# ADMINISTRATIVE AMENDMENT

TRANSPORT APARTMENTS  
3000 TRANSPORT ST SE  
ALBUQUERQUE, NM 87106

AMENDED

DRAWING TITLE		SITE PLAN	
SEAL	DESIGNED	PROJECT NO	
	DRAWN	SCALE	
	CHECKED	DRAWING NO	A-001
	REVIEWED	DATE	10/19/2021

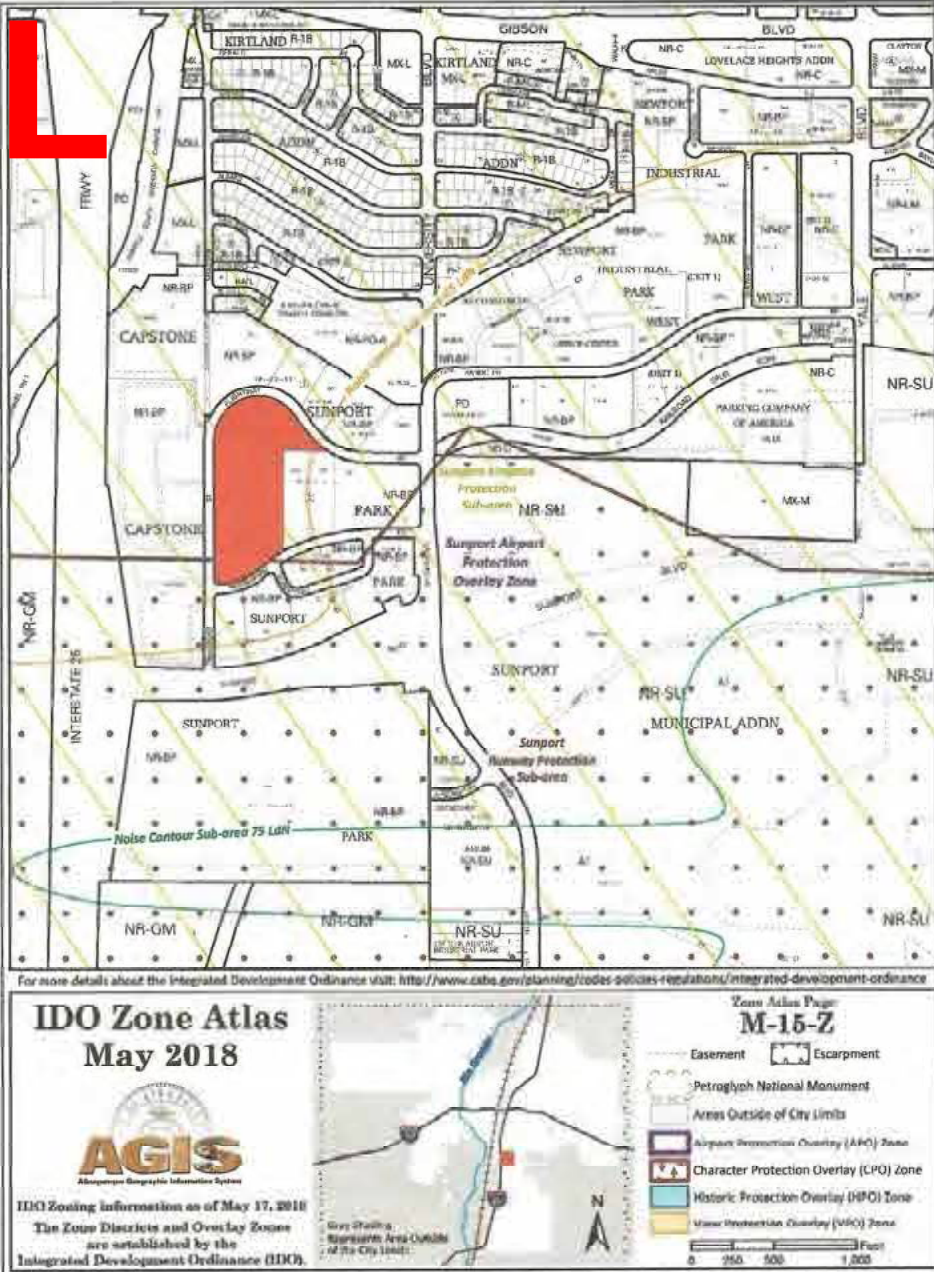
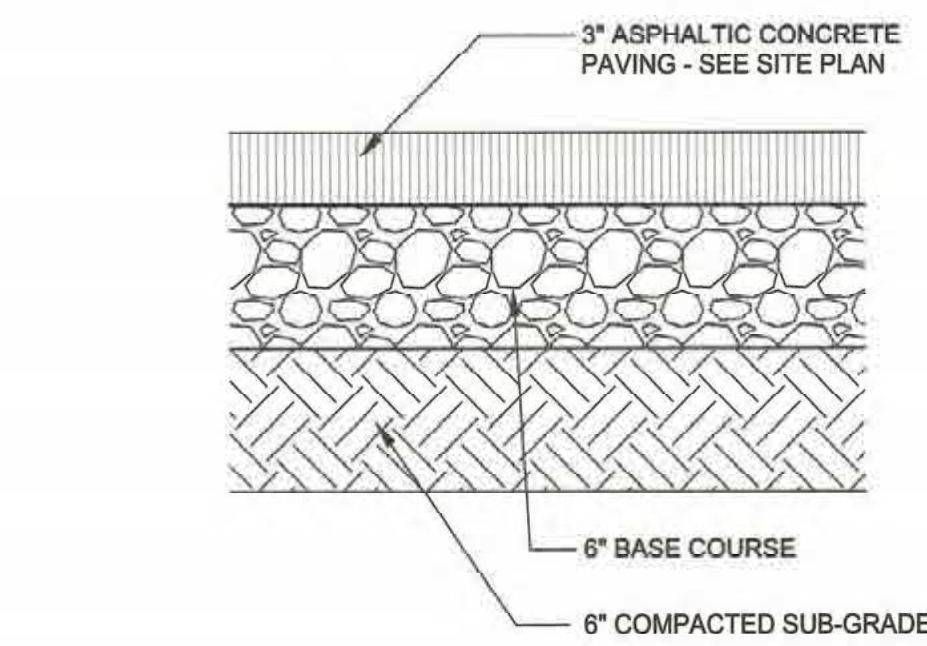
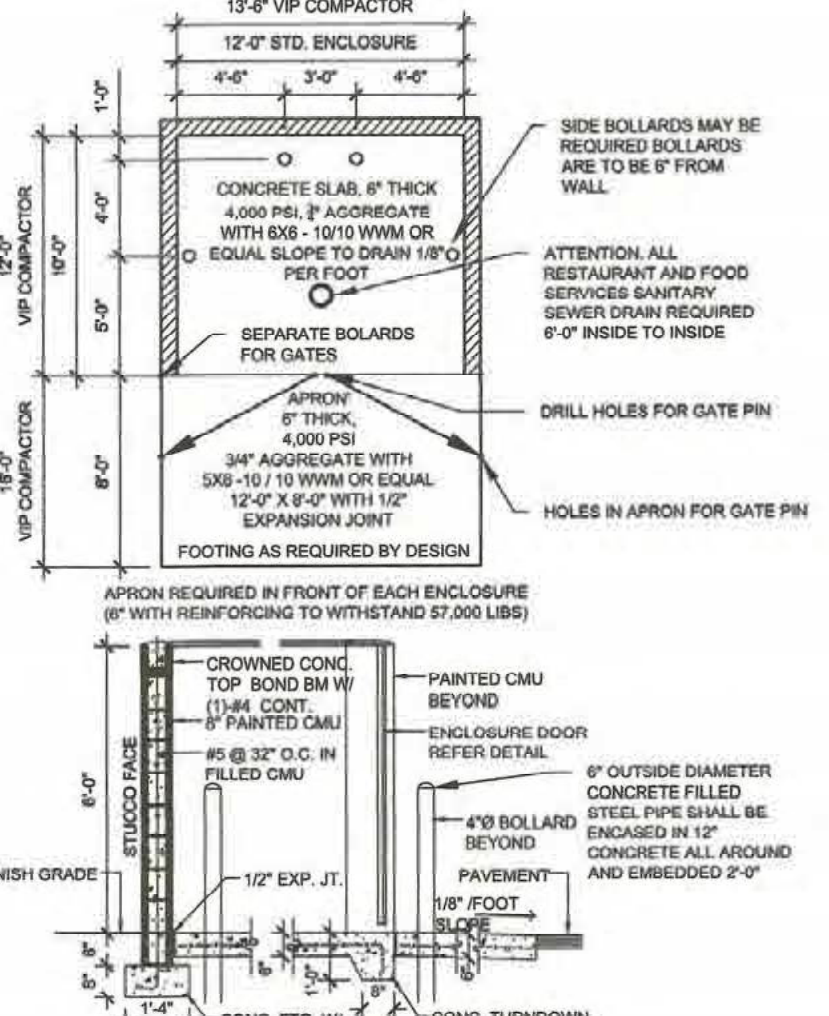
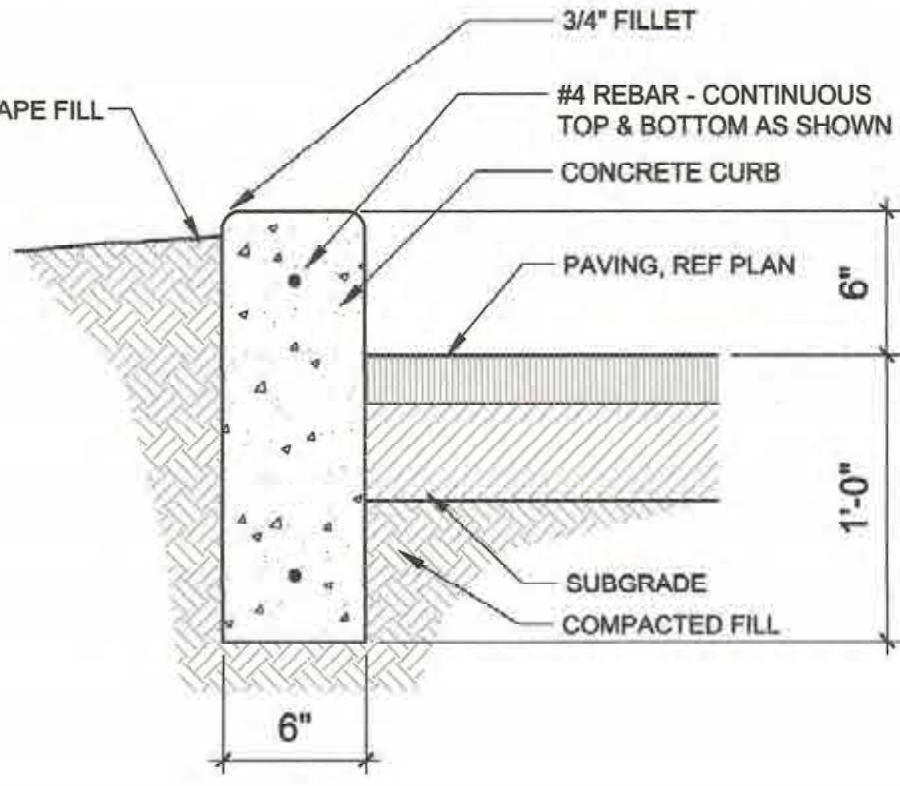
ORIGINAL
